TRUCK, CARGO, HEAVY, MC3 (MACK)
TRUCK, CARGO, WITH WINCH, HEAVY, MC3 (MACK)
CO-AXIAL CAPACITOR - CAB HEATER BLOWER MOTOR

MODIFICATION INSTRUCTION

1. This instruction details the fitting of a co-axial capacitor to the cab heater blower motor to improve RFI suppression.

FIG 1 - MOUNTING OF CO-AXIAL CAPACITOR

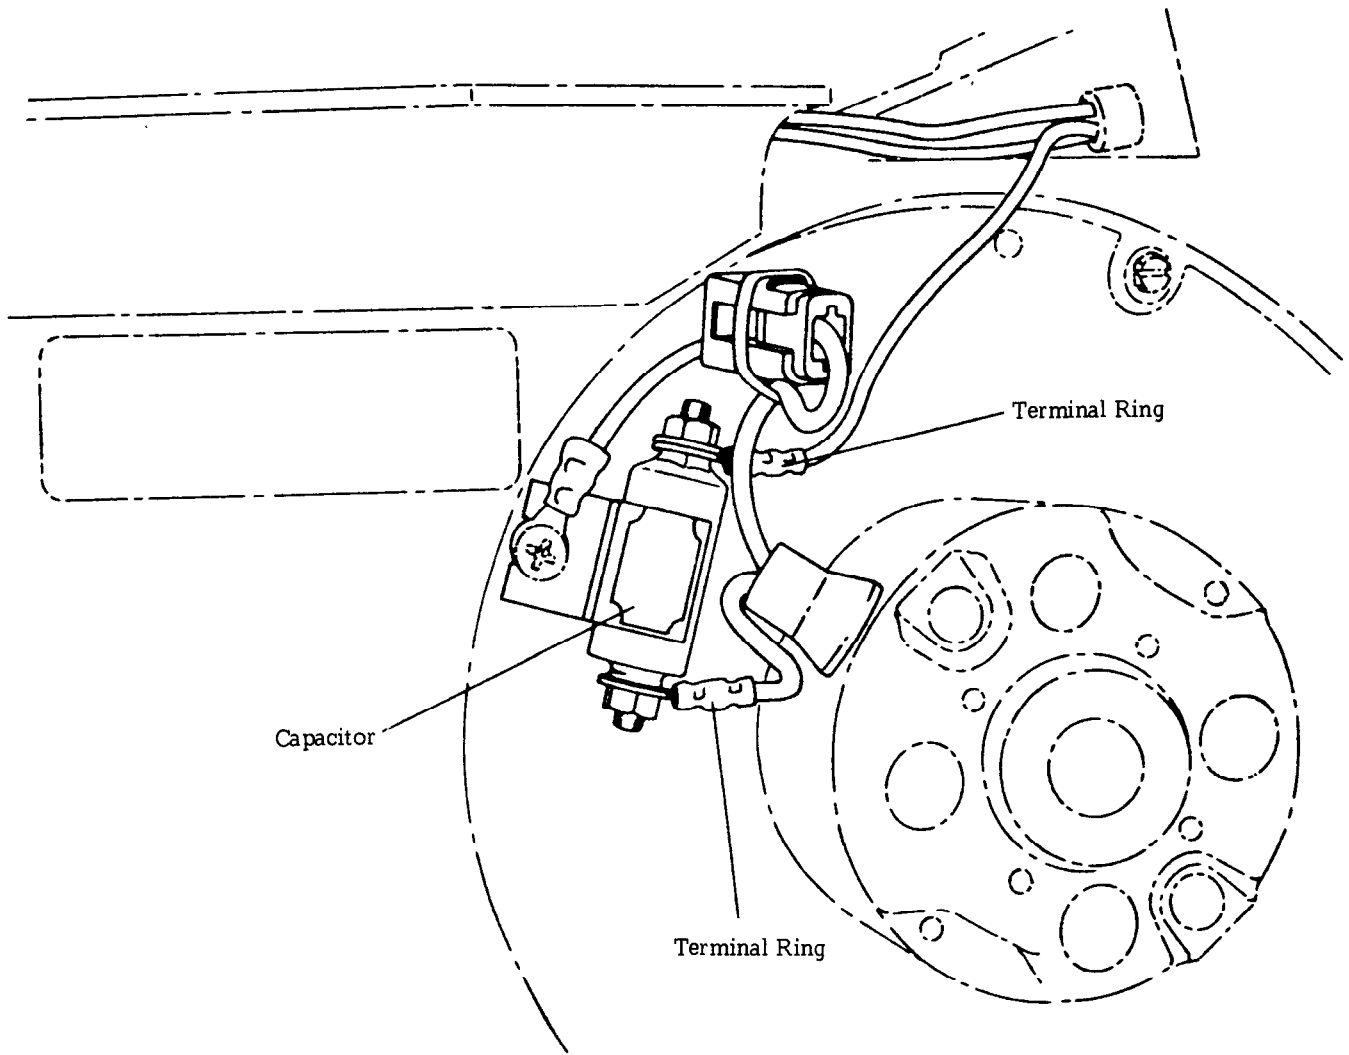
8. To carry out the modification, proceed as follows:
 - a. Trim 10 mm off the end of the capacitor, item 1 from Table 1, mounting tail
 - b. Cut the power connector from the power lead and discard it.
 - c. Crimp suitable 3/16 inch terminal rings to the ends of the power lead, as illustrated in Fig 1, and fit the leads to the capacitor.
 - d. Loosen the screw on the heater body holding the earth lead and mount the capacitor as illustrated.
